Proposed Amendment to the Bellevue Community Plan: 2003 Update

Metro Planning Commission Meeting of 6/23/05

**Proposed Amendment to the Southeast
Community Plan: 2004 Update**

Proposed Amendment to the Collector Street Plan

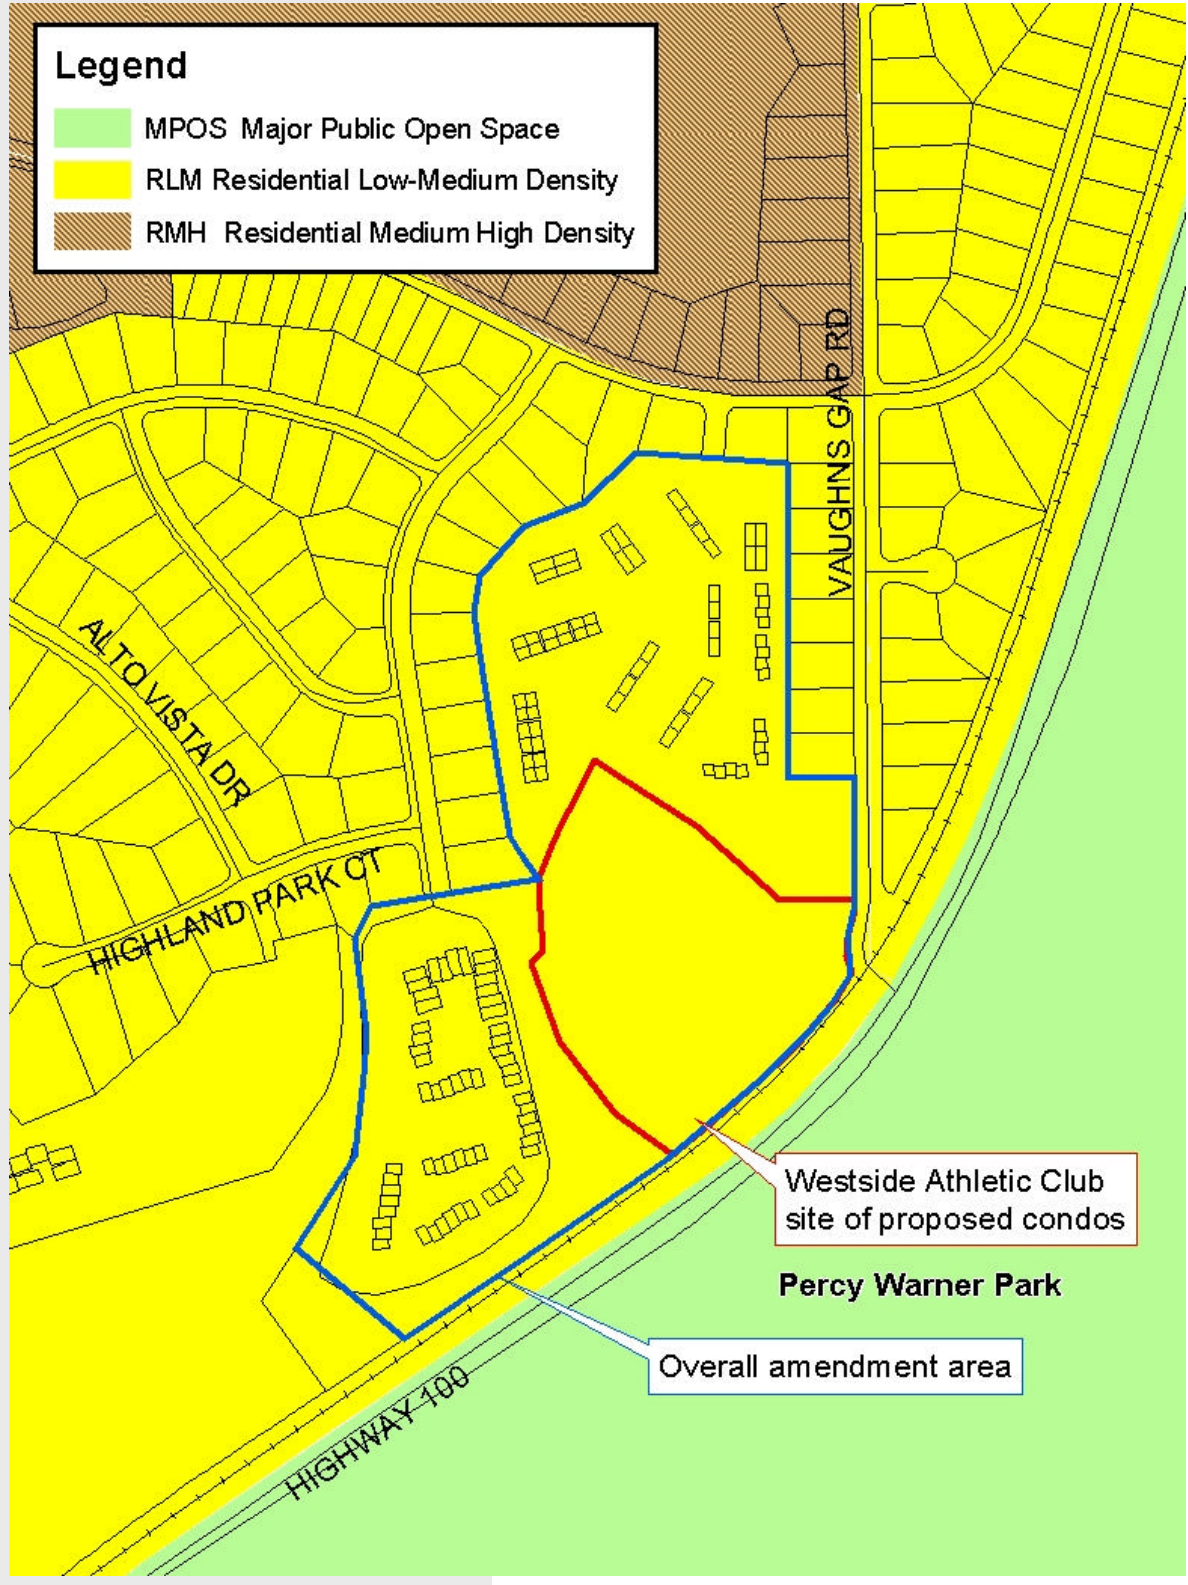
included in the Residential Low medium Density policy area. These are the Harpeth Glen condos (5.27 dus/acre) and Belle Meade Highlands condos (8.83 dus/acre). The graphic shows both the amendment area requested by the applicant and the overall amendment area as expanded by staff.

Staff believes that the policy change is appropriate because the Westside Athletic Center property is sandwiched between existing medium density housing and would be a completion of that pattern. Application of RM policy here would to a large degree recognize a situation that has been in existence for a long time and, if responsive to the existing scale of development and to hillside considerations, would provide for compatible infill.

***Special Policy 7** applies to an approximately 33 acre area at the end of Vaughns Gap Road and Highland Park Drive, adjoining the railroad tracks. Much of this area is already developed with medium density housing and an athletic club. Existing buildings range from one to three stories in height. The intent is for the height of new buildings to be compatible with existing buildings in this area, respect the views from the scenic corridor and nearby park, and respond sensitively to hillside development considerations. Therefore, the height of new buildings in this special policy area shall not exceed three stories anywhere on the site.*

In addition, applications for changes in zoning in this special policy area shall be accompanied by a Planned Unit Development or other design overlay in order to ensure the compatibility of infill development with surrounding development and with site characteristics such as topography and drainage.

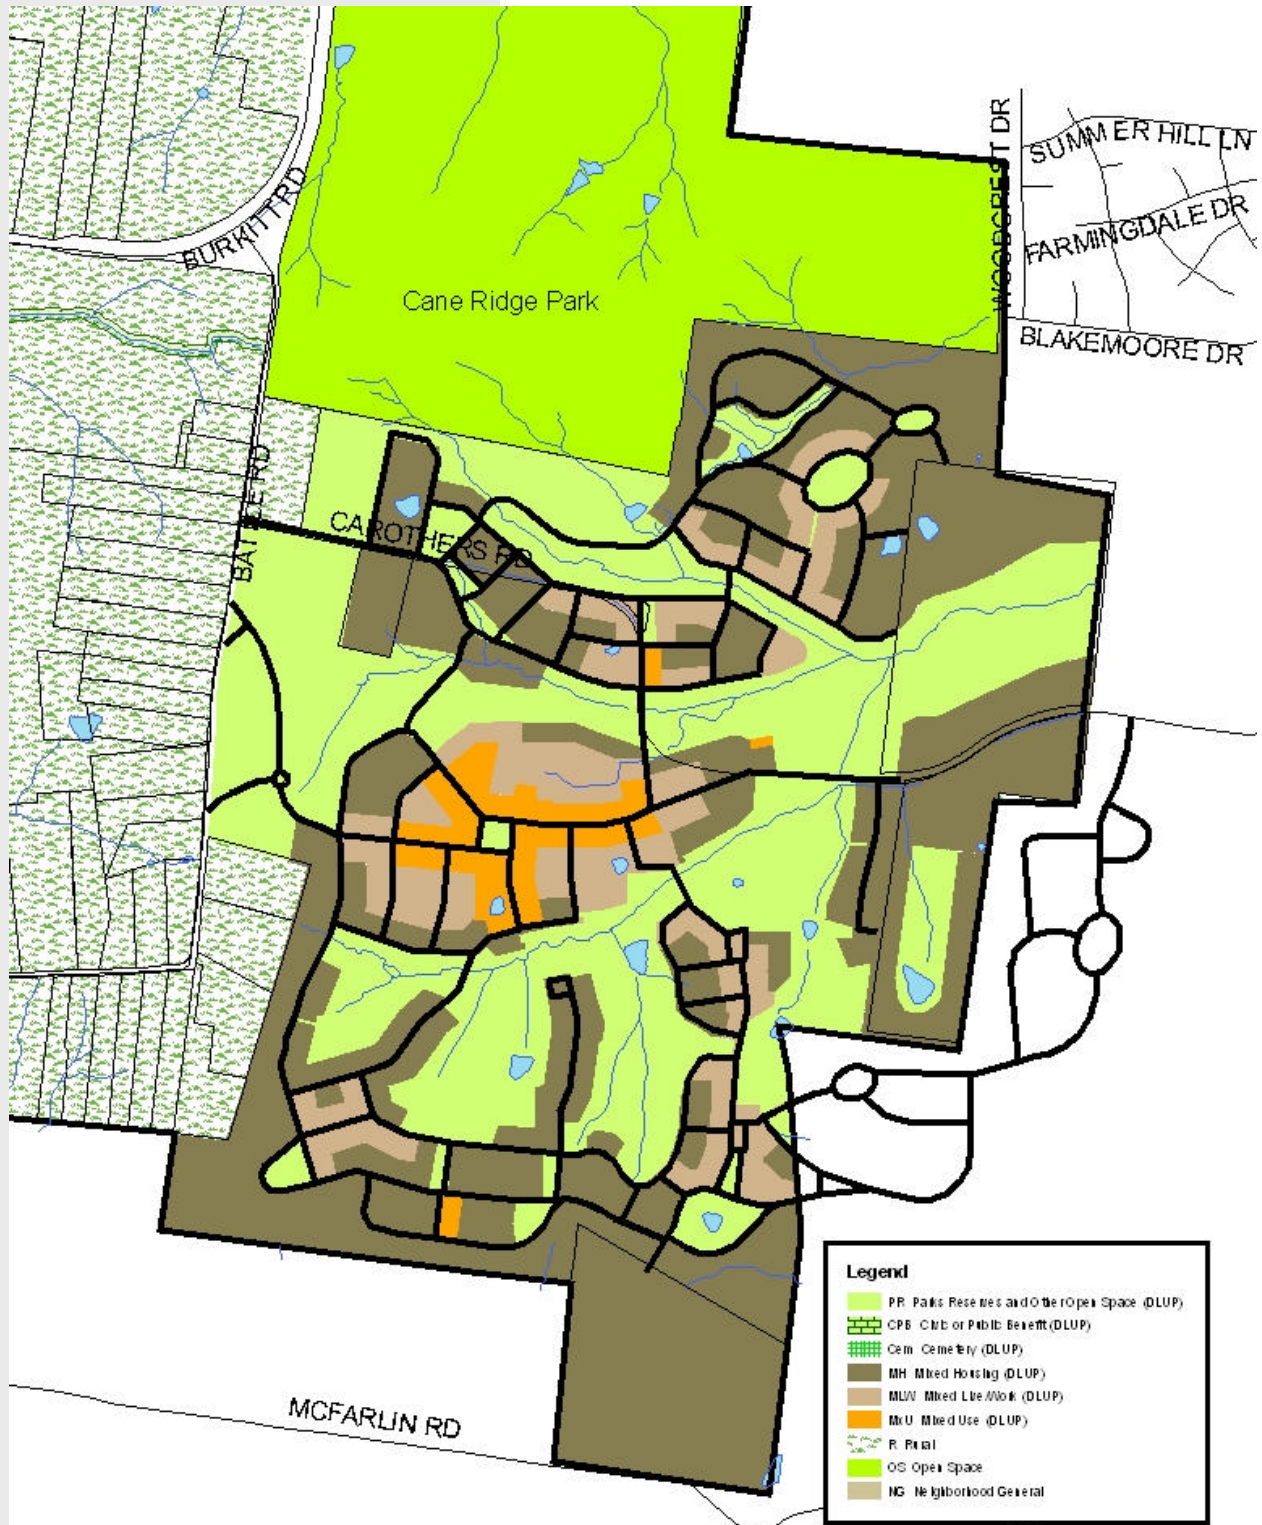
The recommended policy arrangement is shown on the accompanying graphic. Please note that the amendment

area includes a few parcels that are not part of the UDO but are either surrounded by it or are sandwiched between it and Rutherford County. Therefore, staff has assigned policies to these properties that reflect a logical continuation of the development pattern of the UDO. These properties, if ever developed, should be required to develop according to a UDO.

The community plan amendment also involves changes to its transportation plan component. The street network that is contained in the UDO will be added to the community plan's network of Required Street Connections. This interconnected street network also enables Carothers Road to be redesignated from a Collector to a Local street (see related Collector Street Plan amendment). The street network is also shown on the graphic.

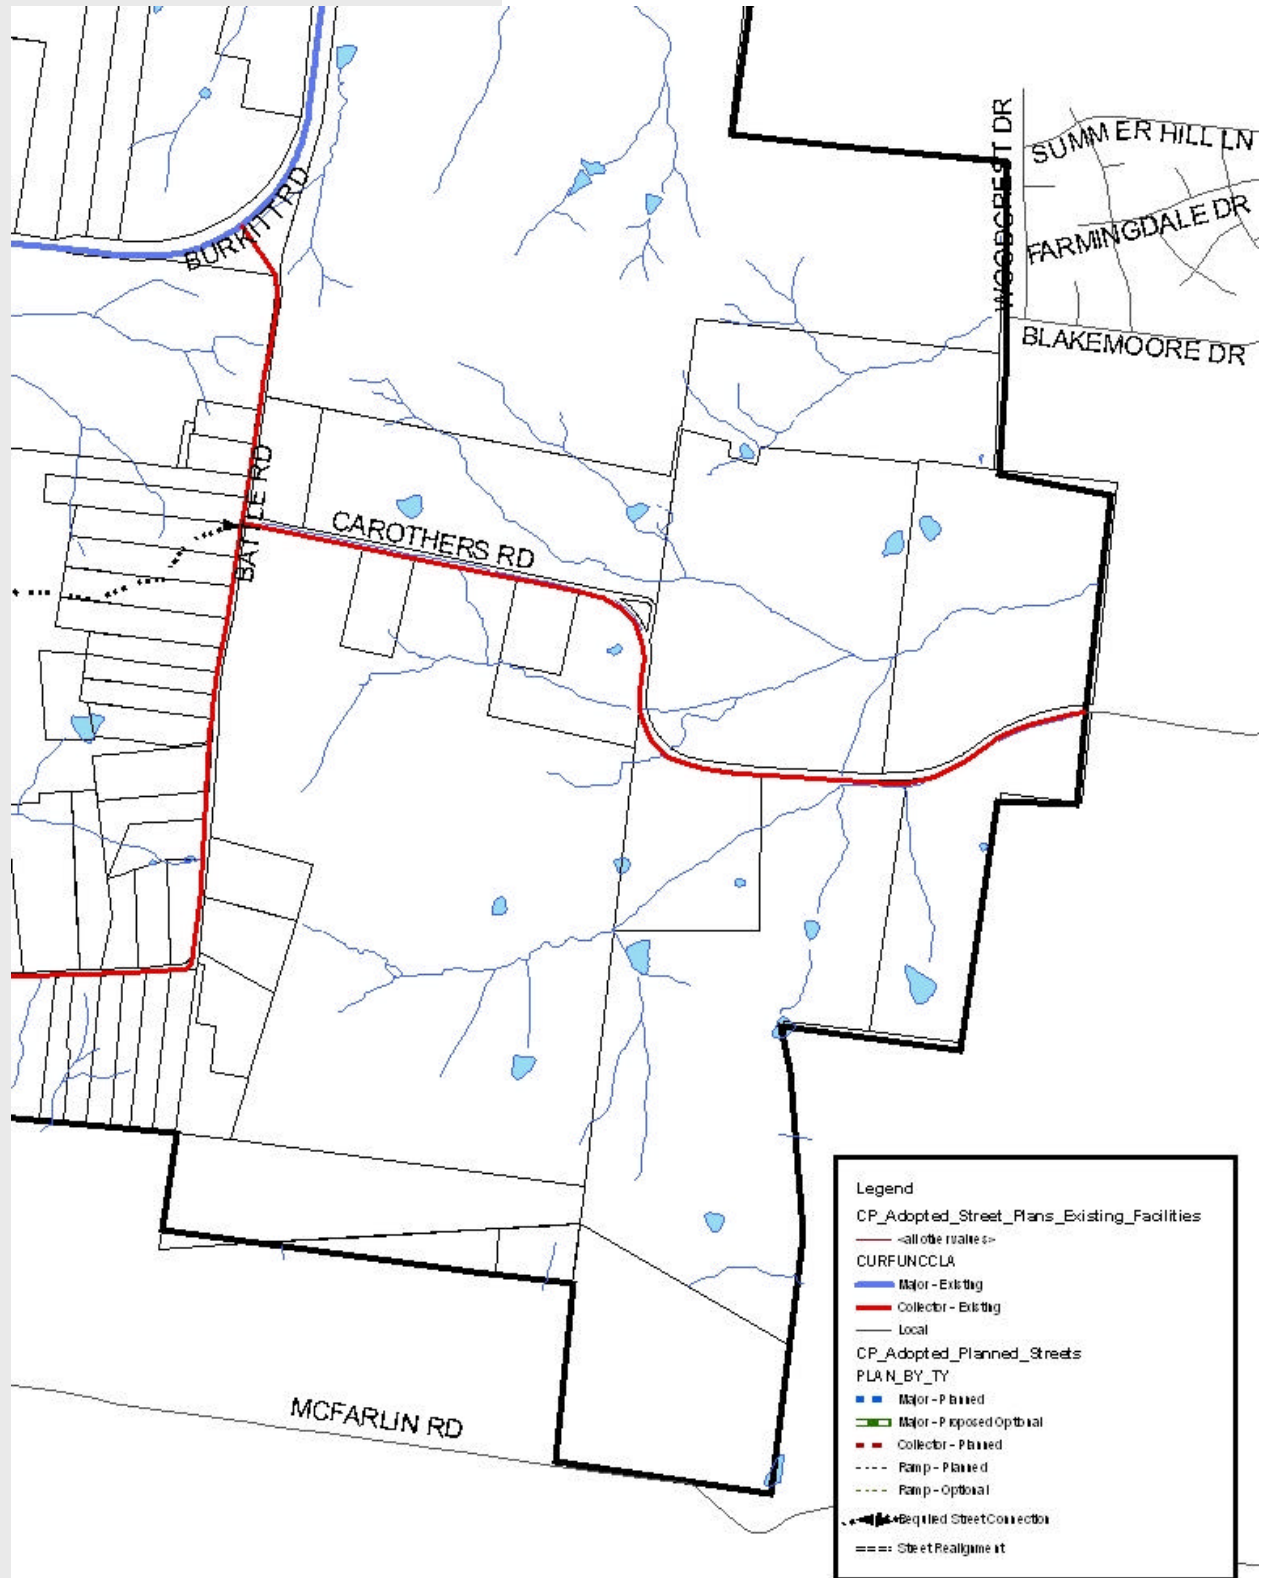
What has been done in the street network proposed for this development is that the east-west function provided by Carothers Road has been assigned to two east-west local streets instead, both of which connect to Battle Road as well as to the remainder of Carothers Road in Rutherford County. These two streets are highlighted in red on the second graphic. Additionally, a dense network of local streets would be connected into these two east-west streets. Some of these other local streets would also provide access outside the project site.

A required Traffic Impact Study prepared for the developer documents that the two east-west streets will operate successfully in circulating traffic through and within the project site. All four of the key intersections along these streets will operate at Level of Service C or better in both the AM and PM peak hours on a scale from A to F where A represents the best level of service and F represents the worst. Level of Service C is an
